# COMMERCIAL/INDUSTRIAL (SCHEDULE O)

### MULTI-FAMILY RESIDENTIAL (SCHEDULE P)

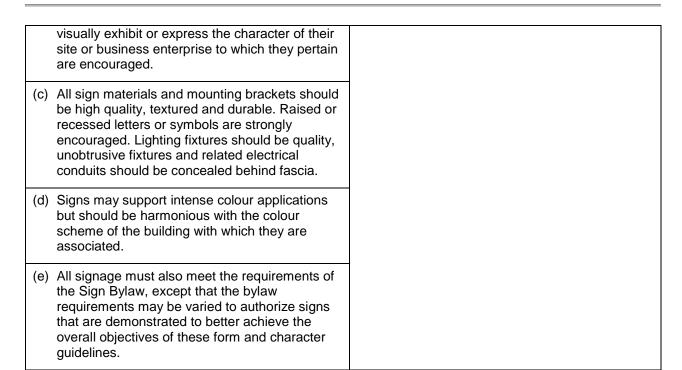
Lighting for the buildings and swimming pool area have not been detailed. Staff recommend a condition in the development permit be that all outdoor lighting have full cut-off and fully shielded fixtures that shield the light source to reduce plare.
